Planning Commission Meeting Agenda
Hartland Township Hall
Thursday, August 11, 2022
7:00 PM

Subject: Site Plan #22-009 Charyl Stockwell Academy-Building Addition

RE: Charyl Stockwell Academy – Concept Plan Review Response
SDA Review No. HL22-114
IA Project No. 20220121

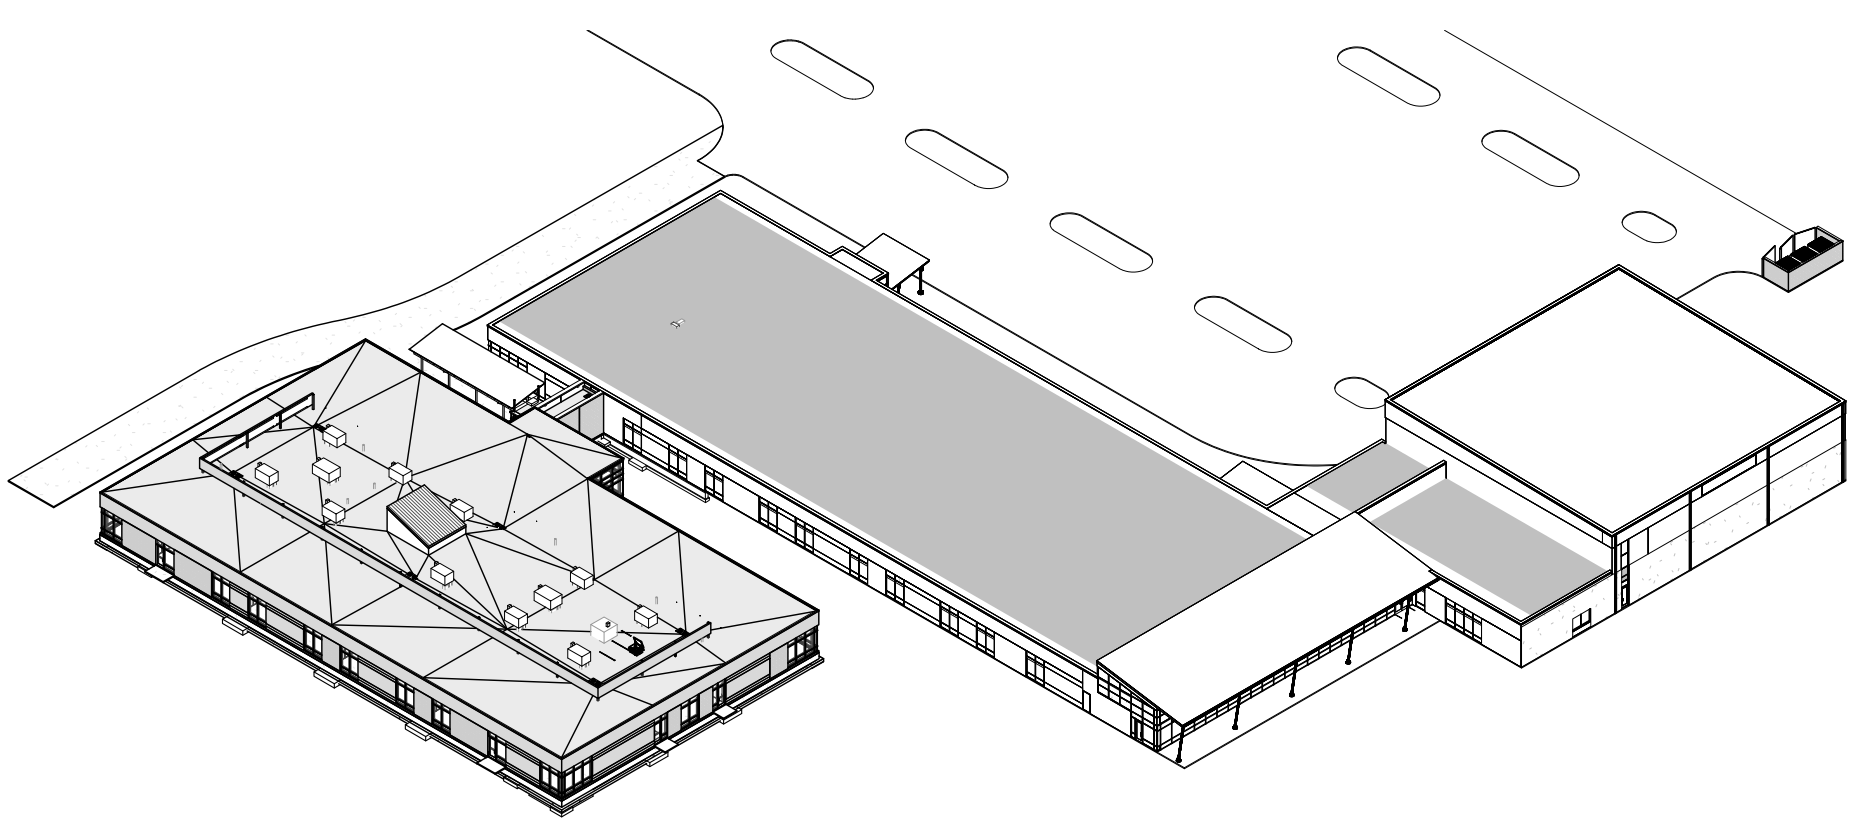
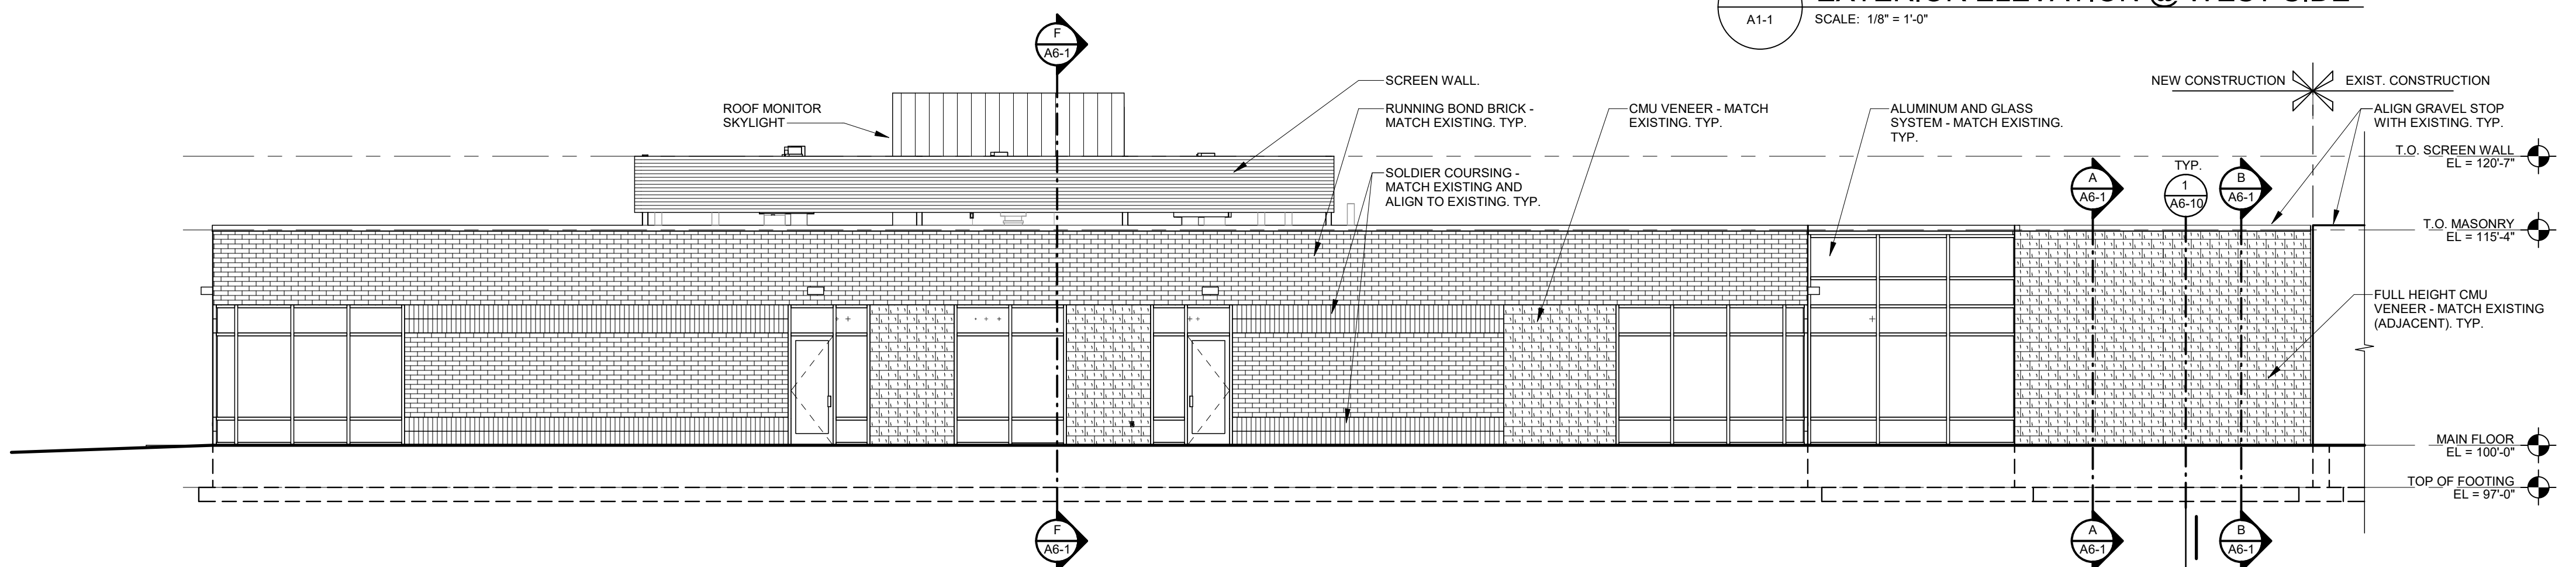
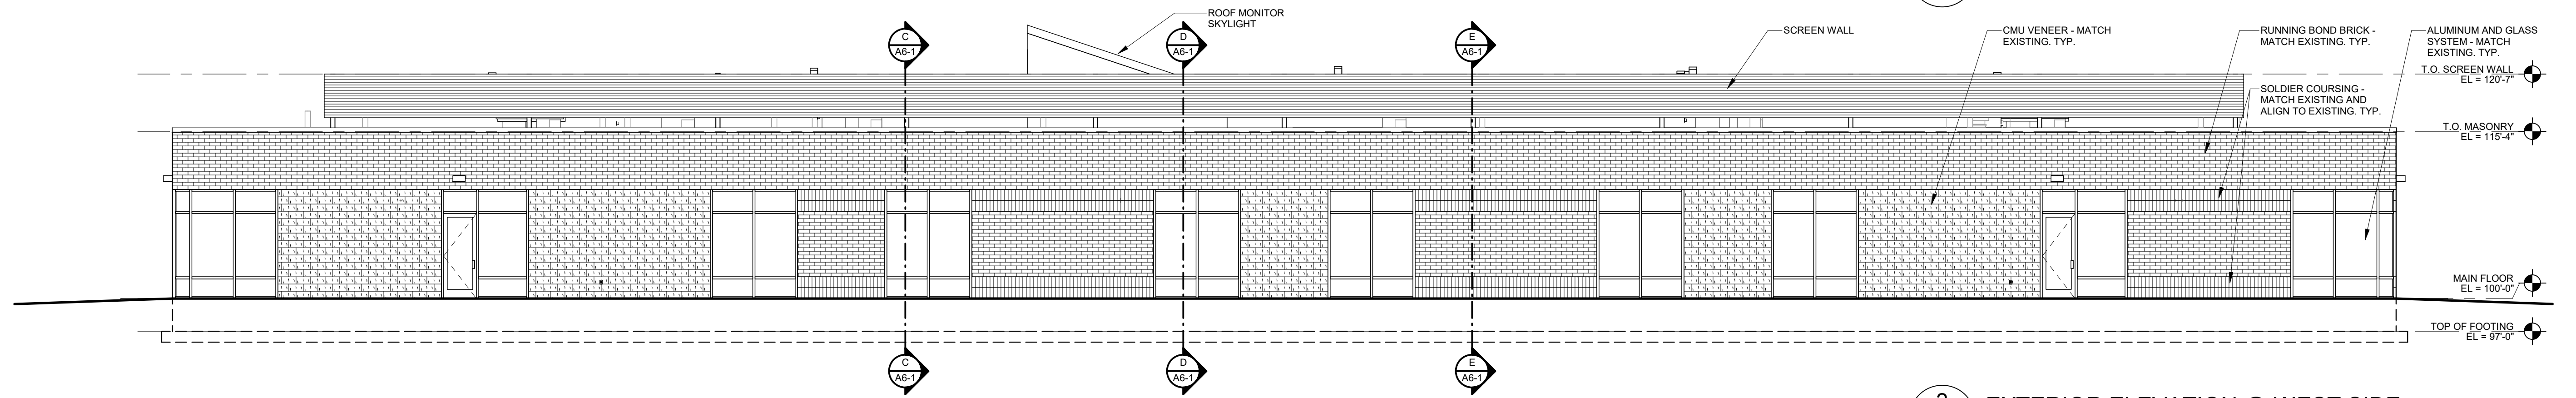
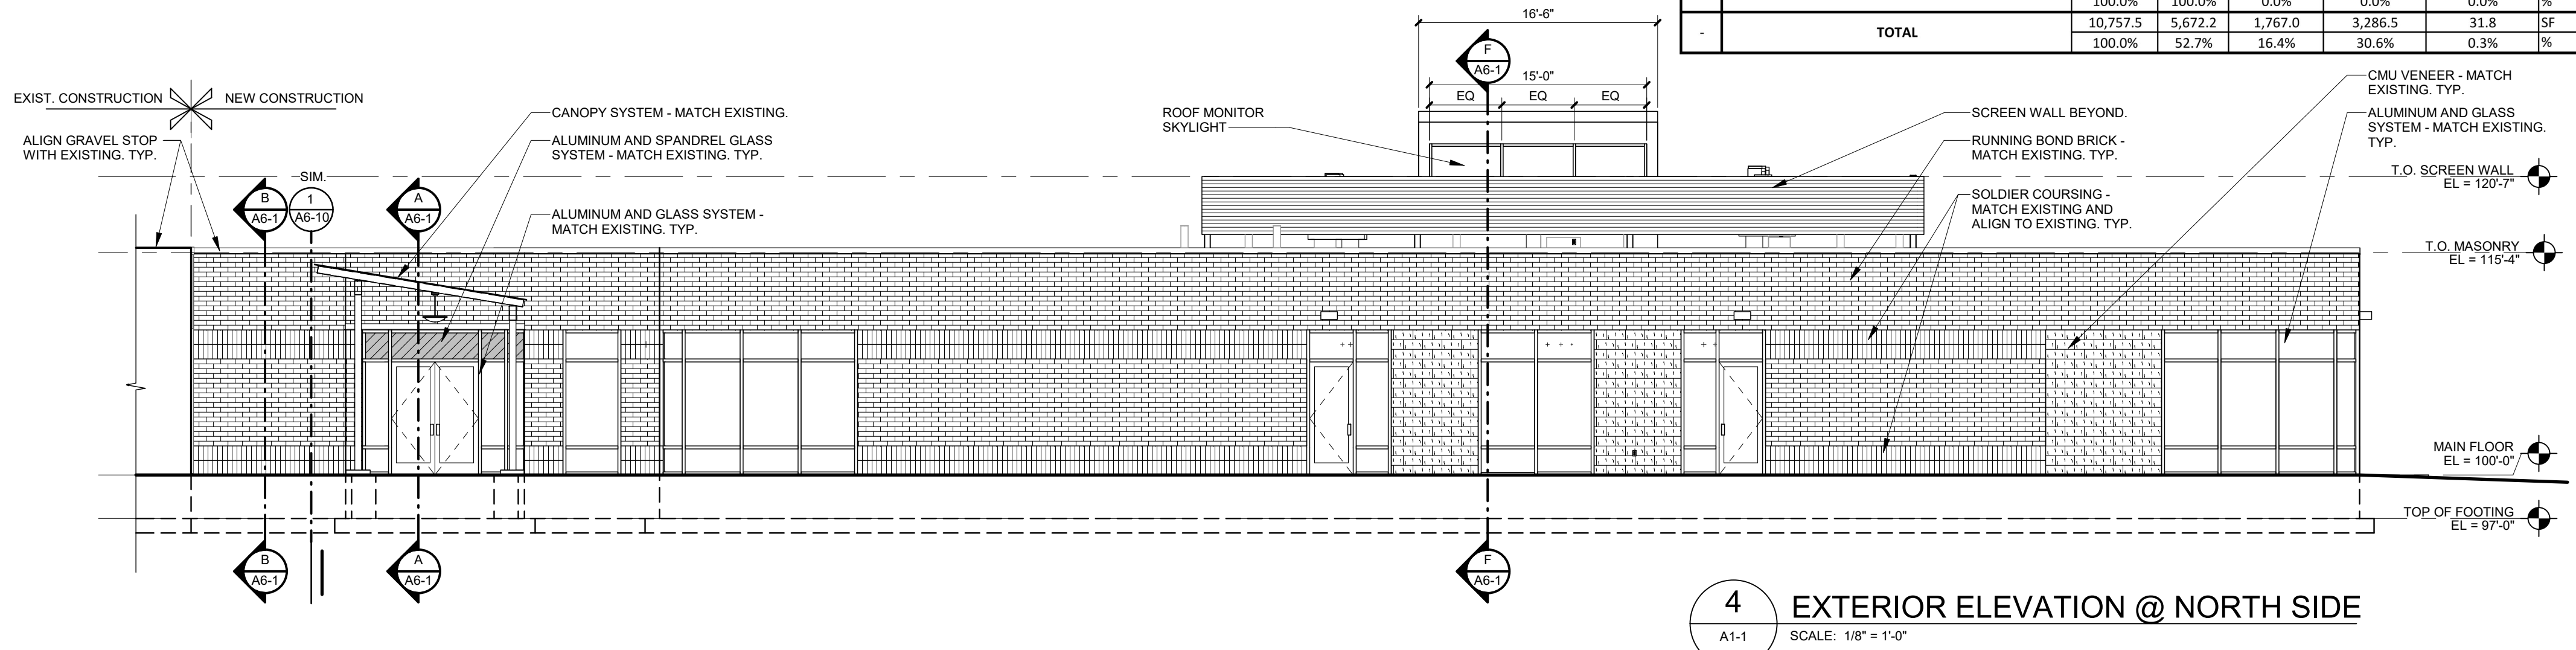
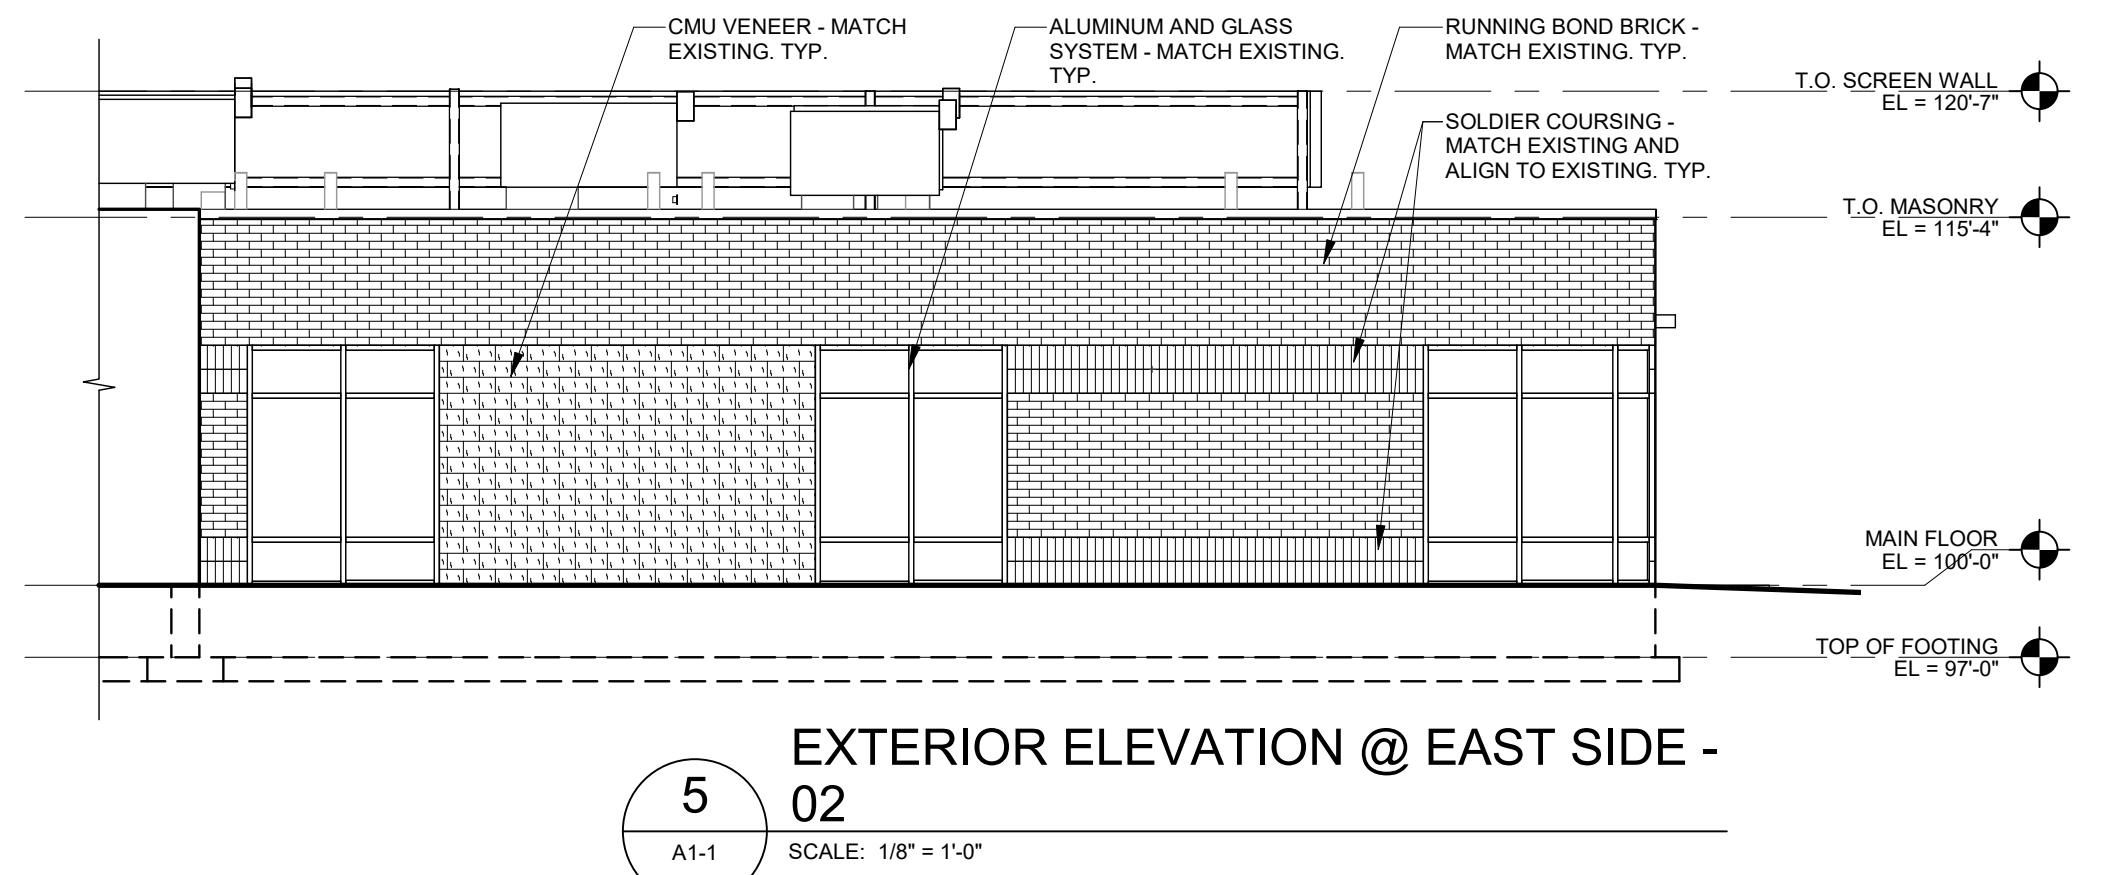
8. Please label the skylight on Sheet A4-1 and Sheet A5-1.

Response: See attached sheets with added labels.
